North Tyneside Council

Murton Gap Engagement Statement

December 2017

South East Wildlife Corridor

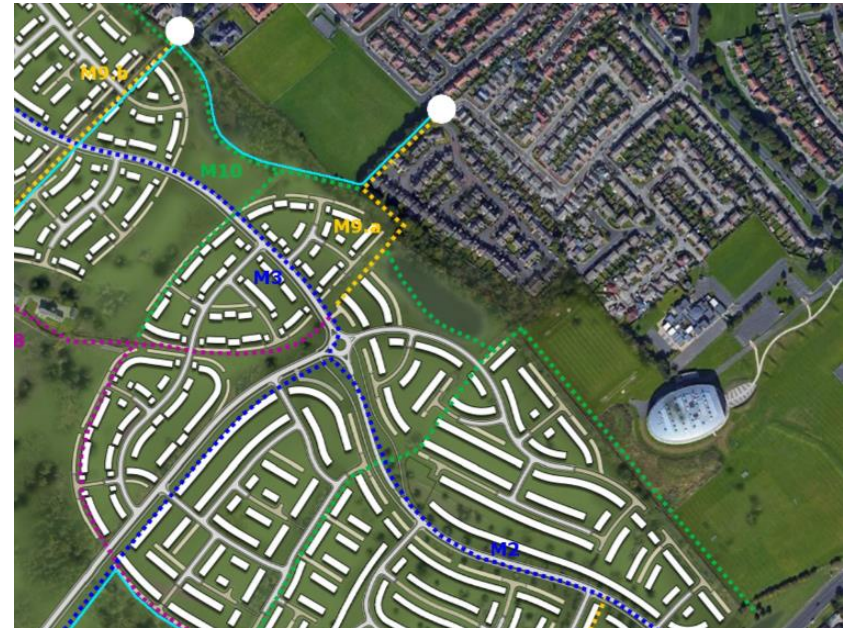
The wildlife corridor to the south east corner has been increased in size. The wildlife corridor in the consultation layout was approximately 24 – 27 metres to the rear of Rake House Farm. This corridor has now been increased to approximately 50 – 70 metres behind Rake House Farm. The wildlife corridor along Rake Lane (opposite the hospital) has also been increased from approximately 27 metres to approximately 45 metres.
